**CULTURAL RESOURCES OFFICE
 PRESERVATION BOARD - REGULAR MEETING
 MONDAY FEBRUARY 24, 2014 — 4:00 P.M.
 1520 MARKET ST. #2000
www.stlouis-mo.gov/cultural-resources**

DATE: February 24, 2014
 ADDRESSES: 2828-2834 Ohio Avenue
 ITEM: Preliminary Review: demolition of five rowhouses prior to new construction
 JURISDICTION: Gravois Jefferson Streetcar Suburb National Register Historic District — Ward 9
 STAFF: Betsy Bradley, Director, Cultural Resources Office

DATE: February 24, 2014
 ADDRESS: 2842 Magnolia Avenue
 ITEM: Preliminary Review: demolition of 2842 Magnolia prior to new construction
 JURISDICTION: Fox Park Local Historic District, St. Francis de Sales National Register Historic District and Preservation Review District — Ward 6
 STAFF: Betsy Bradley, Director, Cultural Resources Office

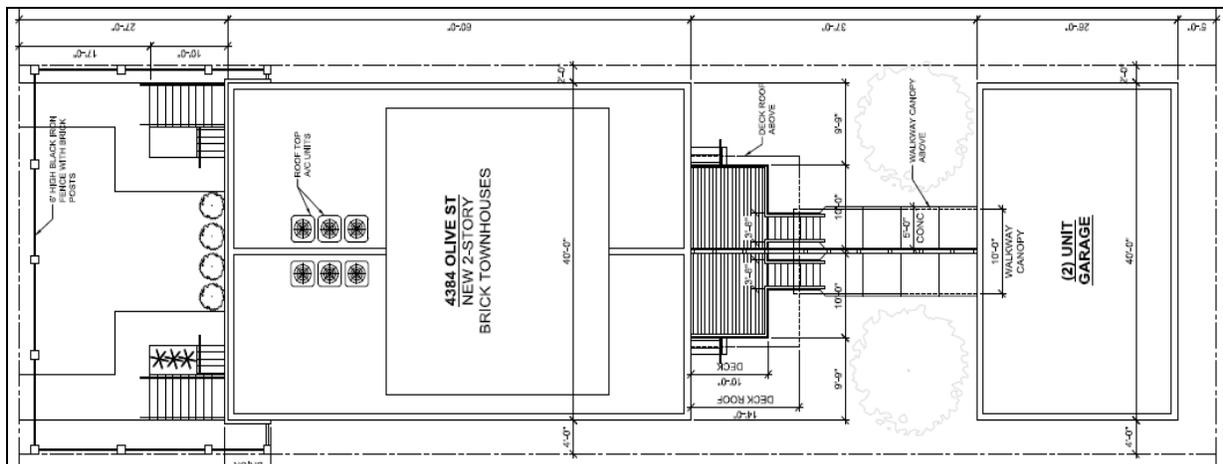
feasible or more appropriate materials shall be used. New walls, fences and other enclosures shall be brick, stone, stucco, wood, wrought iron or evergreen or deciduous hedge when visible from the sidewalk or street, as is consistent with the existing dominant materials within the historic district.

Complies.

PROPOSED VINYL WALLS FACING SIDNEY STREET

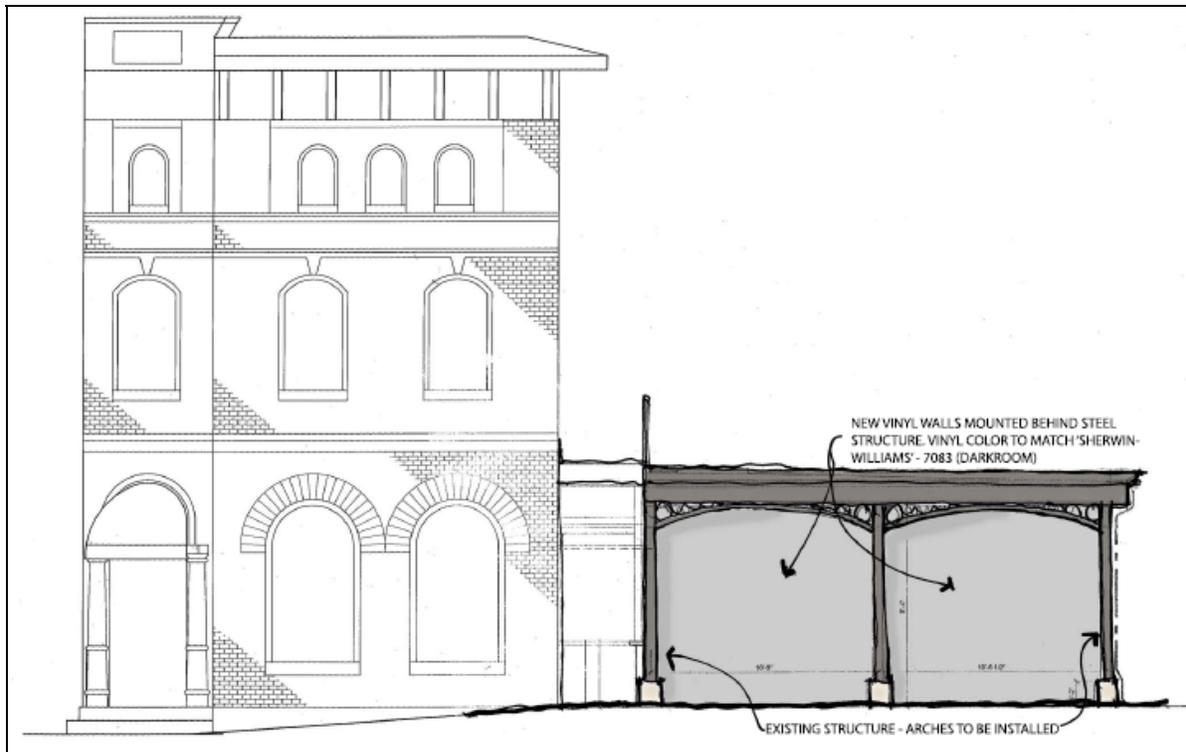
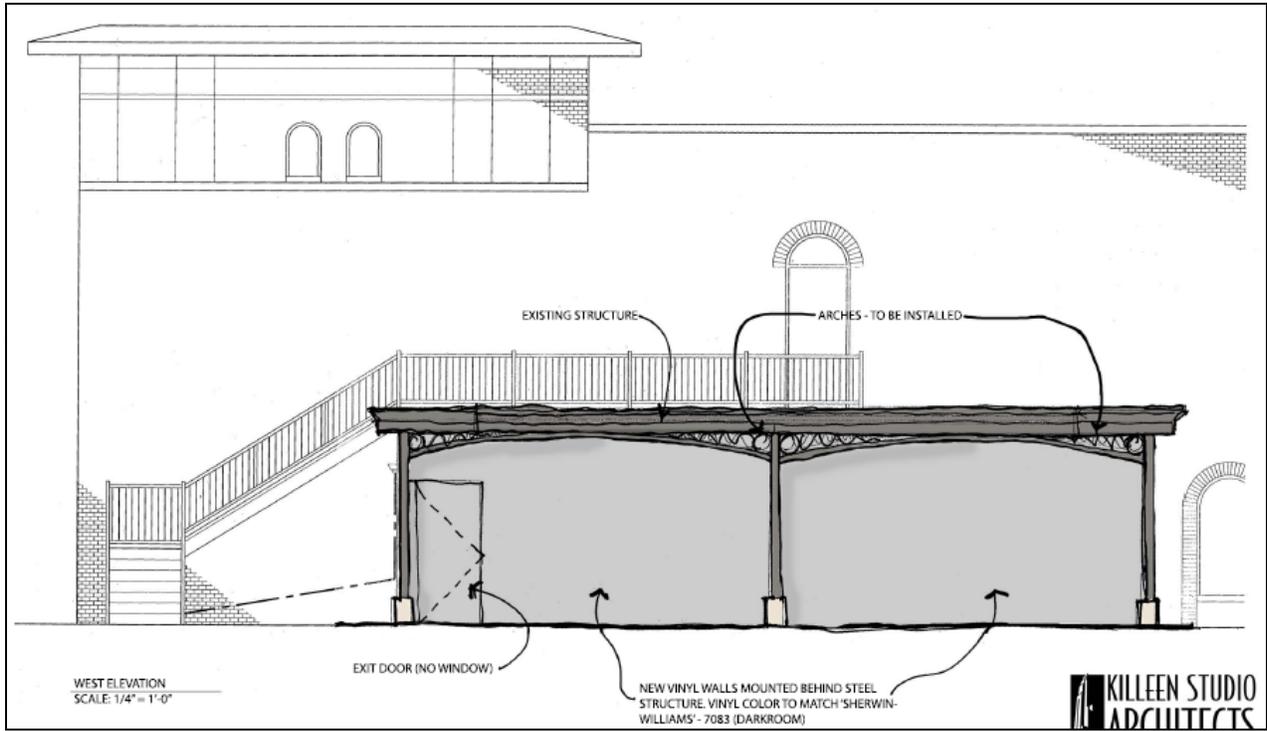
The alteration of that structure with vinyl tent walls during the colder months is not based on a Model Example. The gazebo-like structure would be seen from the street as an entirely enclosed structure with a door.

- 1000 Sidney is located in the Soulard Local Historic District.
- The project is being brought back to the Board to consider a revised design, an approach that a Board members suggested might be acceptable.
- The proposed enclosure with vinyl tent walls does not comply with the Soulard Historic Standards and is not based on a Model Example, as required by those standards.
- The vinyl tent walls are proposed for seasonal use.
- The proposed walls will be a dark color and will be placed behind the columns and decorated arched elements. The door has been moved to the west side to limit its visibility.
- The enclosure will be constructed on a Semi-public Façade and two sides of it would be highly visible from Sidney Street.

Based on these preliminary findings, the Cultural Resources Office recommends that the Preservation Board deny the Preliminary application for the addition of vinyl walls to the roofed structure on the patio as that alternation would not be in compliance with the Soulard Historic District Standards.

**FRONT ELEVATION — NOTE SIDED AREA
CROSS-HATCH AREAS INDICATE COLOR CHANGE**

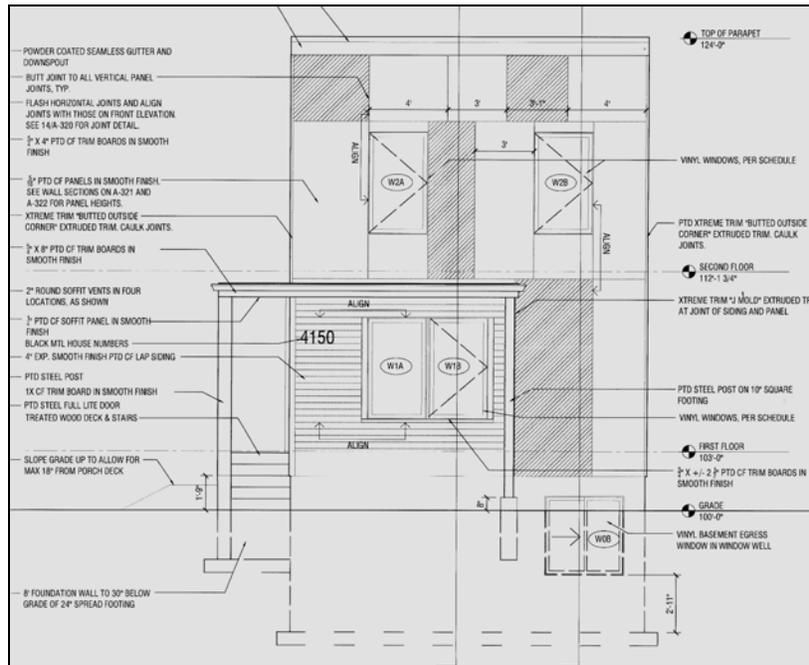
The majority of the front elevation, and a substantial part of both side elevations, will be sheathed in cement panels, coated to replicate the appearance of the metal panels originally proposed. Porcelain enamel panels were used occasionally in the district on later infill commercial buildings and never appeared in residential construction. They do not provide a precedent for panels on residential building and are not approvable materials for new construction. Moreover, the arrangement of panels of various shapes and sizes in several tiers is a design element that also has little compatibility with the historic fabric of the area. The use of two masonry colors close in shade and value, can be seen in some of the blended or variegated brick used in historic buildings in the Craftsman style — although never in large color blocks as proposed. Such variation, however, may be acceptable if the two colors are similar in tone and value and do not present a stark contrast.

- As the building is the first in a group of seven proposed buildings, its exterior materials are important for compatibility with the larger district, as well as the immediate new construction.

Based on the preliminary findings, the Cultural Resources Office recommends that the Preservation Board direct the applicant to propose compliant exterior building materials.

DETAIL OF FRONT ELEVATION OF SIDE PORCH

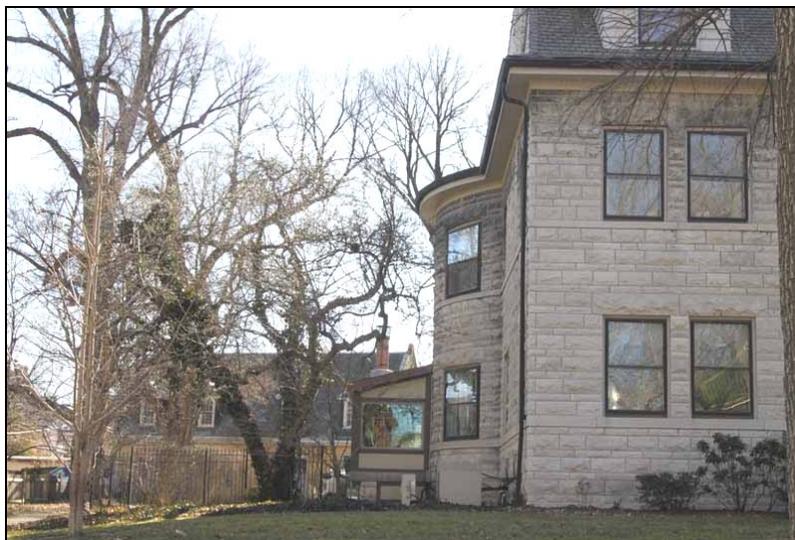
Does not comply. The porch is wider than the previous porch and the details have been altered. The large picture window with interior muntins is not compatible with the design of the main house.

- The project site, 3120 Hawthorne, is located in the Compton Hill Local Historic District.
- The Cultural Resources Office received a Citizen's Service Bureau complaint in February 2013 for modification of a side porch. The owner subsequently applied for a permit which was denied. There was no further contact from the owner at that time.
- The owner was sent to Housing Court for the violation and made a new application for a building permit in December 2013. The permit was denied and the owner has appealed.
- The owner reconstructed an enclosed side porch (built c. 1982) without a permit. The width of the porch could not be altered without completely rebuilding the existing porch.

PROPOSED PORCH ALTERATION

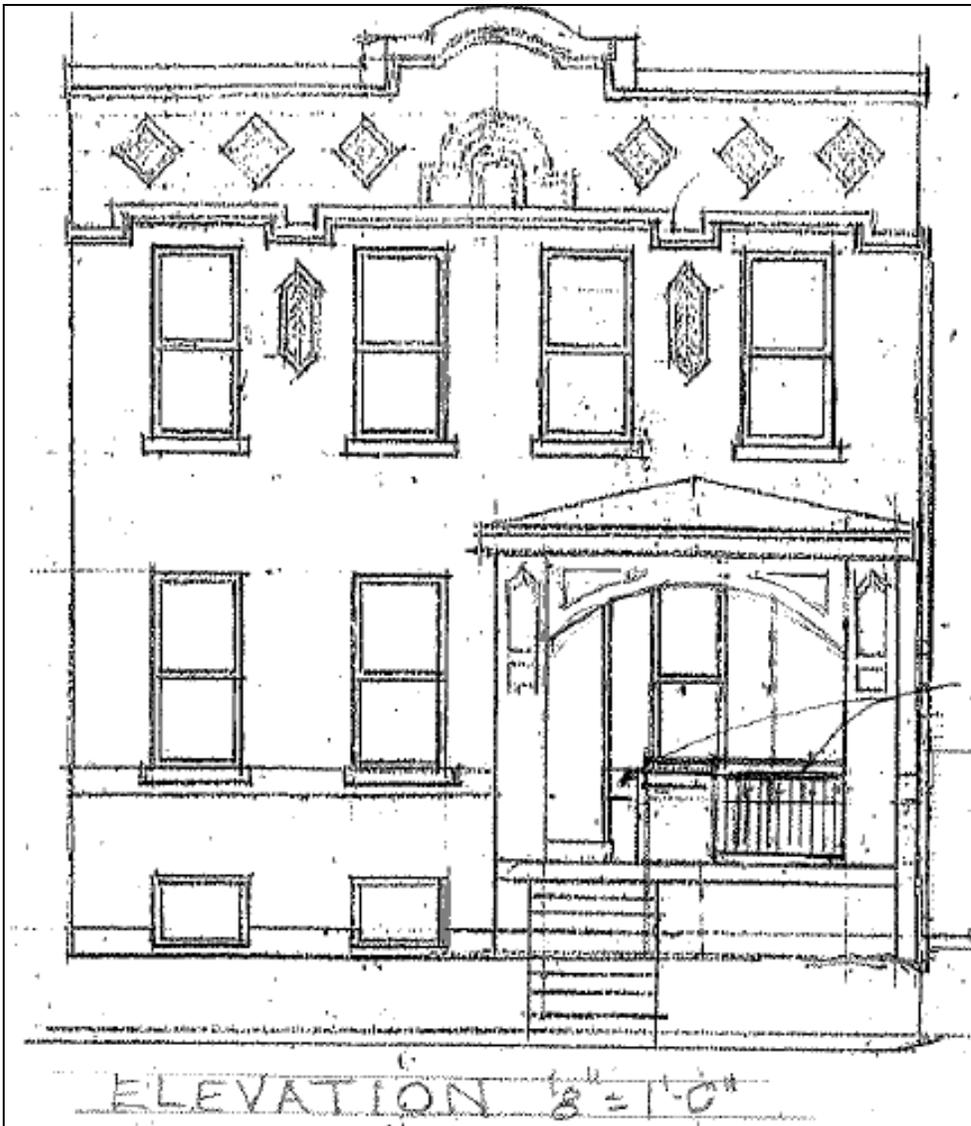
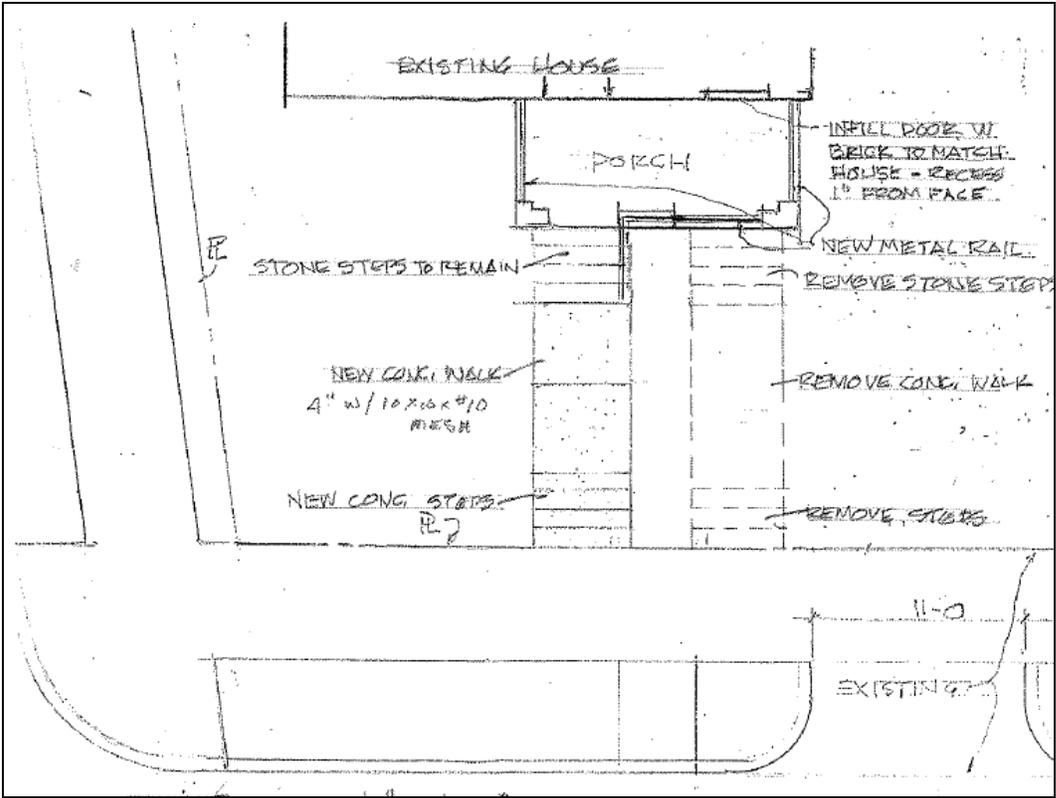
Does not comply. The proposed porch alteration, which would remove the existing center stair and substitute a side stair, enclose the front of the porch with a railing, entirely changes the historic appearance of the porch and presents a contemporary, non-historic configuration.

Based on the Preliminary findings, the Cultural Resources Office recommends that the Preservation Board uphold the Director's denial of the application for the in-filled door and porch alterations as they are not in compliance with the Compton Hill Historic District Standards.

DETAIL OF BRICKED-IN OPENING

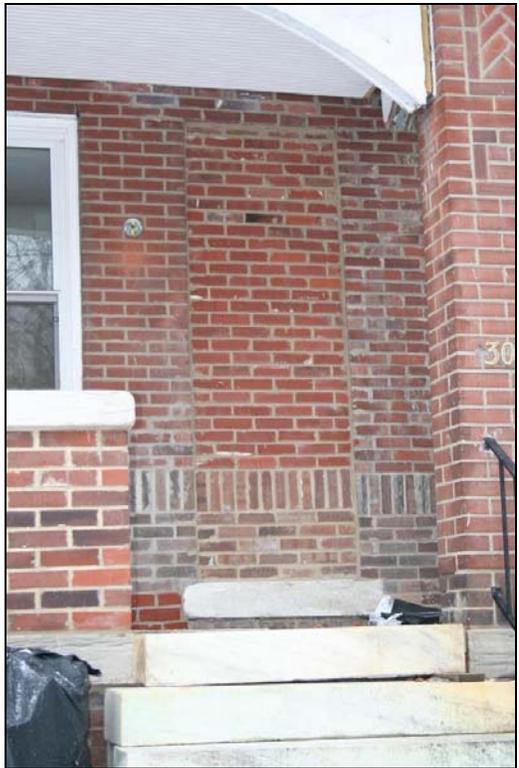
Does not comply. The owner has completely bricked in one of the original front doors altering the appearance of the building from the street and giving it the false appearance of a single-family building.
